FILE: 18-613 ITEM: 10.4

# **SUPPLEMENTAL**

<u>SUBJECT: FILE NO. GP17-013.</u> ADOPTION OF THE WEST SAN CARLOS URBAN VILLAGE PLAN PREPARED BY THE CITY AND THE COMMUNITY TO FURTHER THE URBAN VILLAGE MAJOR STRATEGY OF THE ENVISION SAN JOSE 2040 GENERAL PLAN.

# Changes to the Land Use Chapter

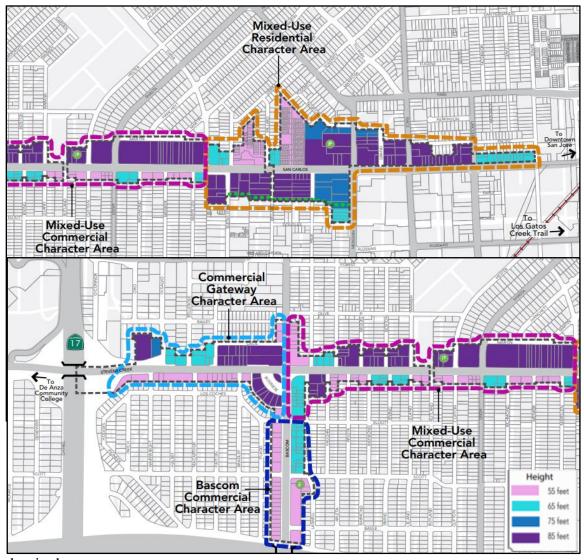
• Modified Building heights to reflect the maximum allowable heights more realistically given parcel depths, opportunity for parcel aggregation, and proximity to existing low-

density homes.

• Removal of the boarder around the floating parks sites to clarify that the park location is approximate and is "floating" in the general area.

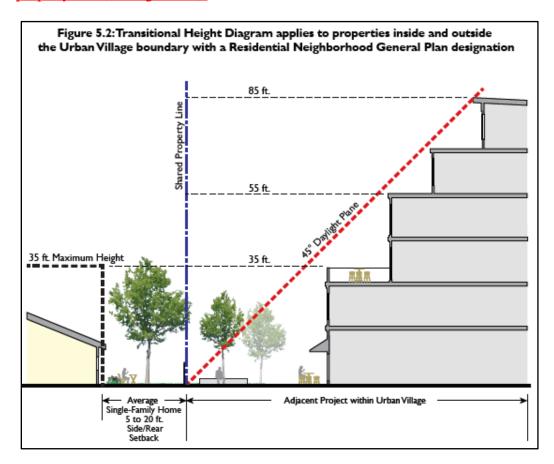
- Updated Urban Design Policy UD-5.3: The following setbacks and stepbacks are intended to maintain compatibility between existing buildings outside of the Urban Village boundary and new development for side setbacks:
  - When a high-density commercial or mixed-use development abuts residential properties with a Residential Neighborhood General Plan land use designation or existing single-family, duplex, or multifamily use outside of the Urban Village boundary, a minimum five-foot side setback will apply.
  - When a high-density commercial or mixed-use development abuts non-residential properties or is located at the corner of South Bascom Avenue and an adjoining street, a zero foot side setback is allowed and encouraged.

For new development adjacent to properties designated Residential Neighborhood (both inside and outside the Urban Village boundary), buildings and structures are encouraged to not intercept the 45-degree daylight plane as measured from the adjoining side or rear property line (see Figure 5.2).

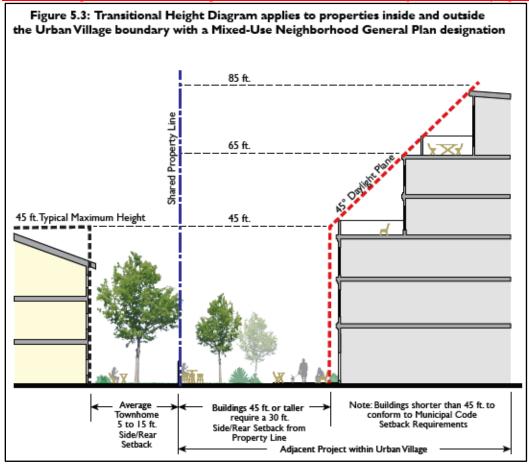
- For new development adjacent to a parcel with a Residential Neighborhood General Plan land use designation or existing single-family or duplex building outside of the Urban Village boundary: 35 feet in height maximum within 40 feet of the property line, thereafter increasing by one foot for every one additional foot of setback. (See Figure 5.2.)
- For new development adjacent to a Mixed Use Neighborhood General Plan designated parcel or existing multifamily or townhome building outside of the Urban Village boundary: 45 feet in height maximum within 40 feet of the property line, thereafter increasing by one foot for every one additional foot of setback. (See Figure 5.3.)

For new development taller than 45 feet, provide a minimum 30-foot side and/or rear setback along the shared property lines with adjacent Mixed-Use Neighborhood designated properties (both inside and outside the Urban Village boundary). Starting at a height of 45 feet, buildings and structures are encouraged to not intercept the 45-degree daylight plane (see Figure 5.3). Buildings shorter than 45 feet shall conform to the San José Municipal Code setback requirements and shall not be subject to the daylight plane.

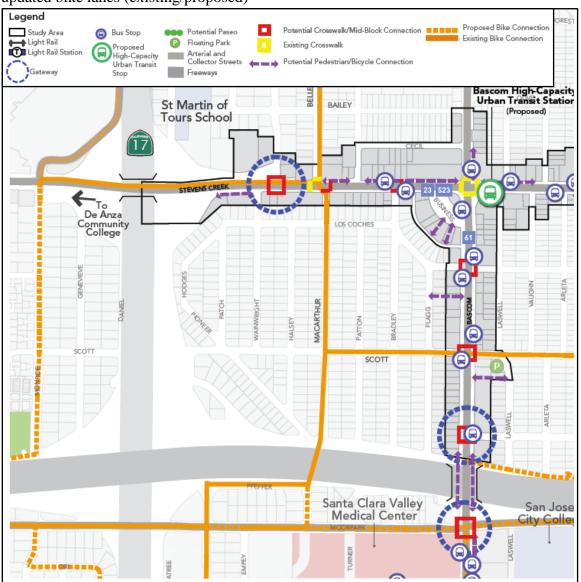
• Updated Circulation and Streetscape Figure 6:3 to show existing cut through traffic.

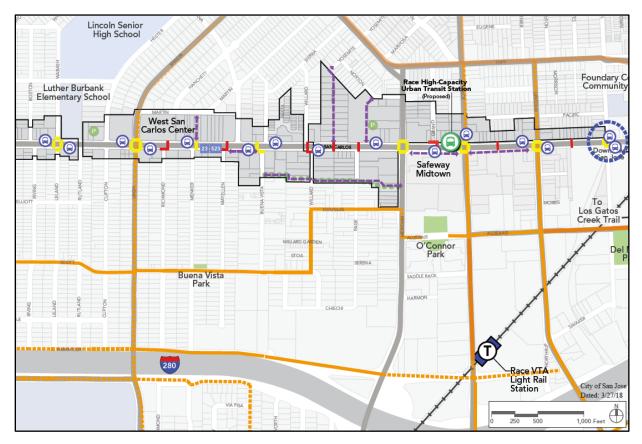
• Updated Circulation and Streetscape Figure 6.4 map to show pedestrian crossing and updated bike lanes (existing/proposed)
